# UNITED STATES PATENT AND TRADEMARK OFFICE

10/525,967

<b>Office Action Summary</b>	<b>Application No.</b> 10/525,967	<b>Applicant(s)</b> DALLIMORE ET AL.	
	<b>Examiner</b> Bena Miller	<b>Art Unit</b> 3725

Figure 15 of Lusty

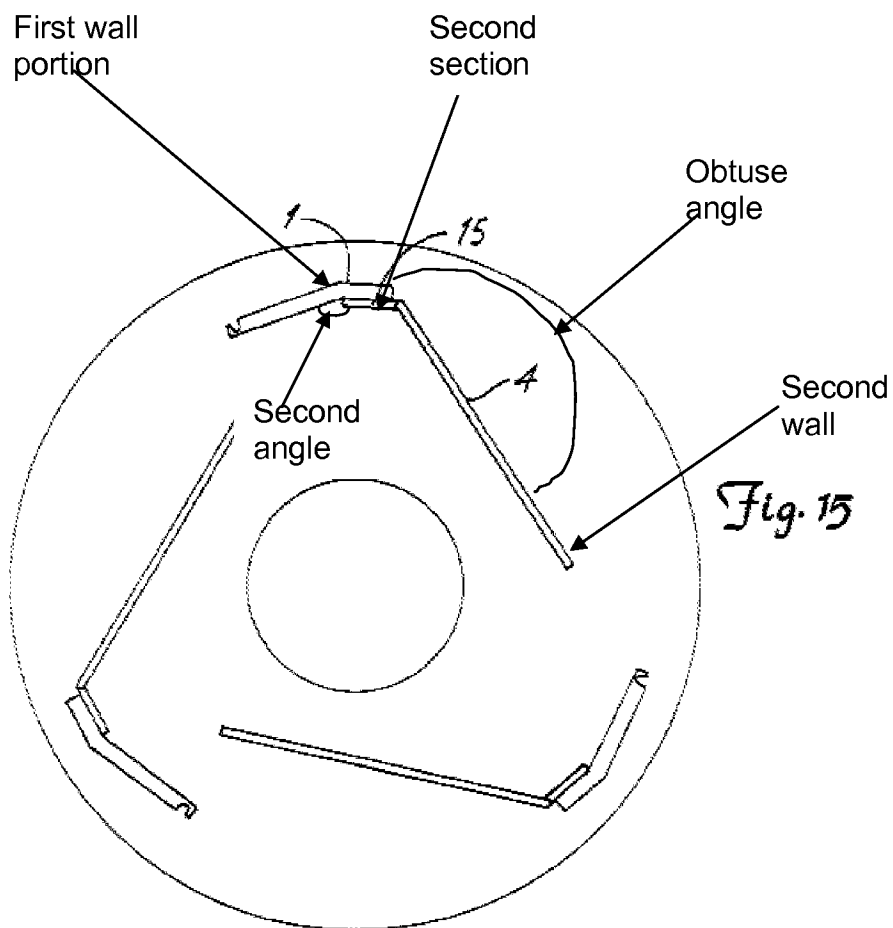
The device of Lusty reads on the claimed invention including rotor (fig.15) comprising a horizontal upper disc and a horizontal lower disc, said discs being separated by at least two vertical wall segments defining between them an outflow opening for material leaving the rotor, said wall segments each having a first wall portion (1) being substantially tangential in relation to the rotor and being located adjacent to the periphery of the rotor and a second wall portion (4) being angled in relation to said first wall portion (fig. 15) and extending from the first wall portion into the rotor , wherein characterized in that said second wall portion comprises a straight first section (fig. 5) extending from the interior of the rotor towards the periphery of the rotor, said first section forming an obtuse first angle with said first wall portion (see marked copy fig. 15), and a second section connecting the first section and the first wall portion, said second section and said first wall portion forming a second angle (see marked copy fig. 15) being smaller than said first angle, said second section and said first wall portion forming at least one pocket for retaining material. Also, a second pocket is formed

between the first and second section as seen in the figure 15 of Lusty. Further, the examiner takes the position that the first angle of Lusty is approximately  $130^\circ$  and the second angle of Lusty is approximately  $94^\circ$

In the event the applicant disagrees with the rejection above, it would have been obvious to one of ordinary skill in the art to have the first and second angles of Lusty between the claimed ranges for the purpose of providing a bed support that will allow accumulated material to flow before exiting the rotor.
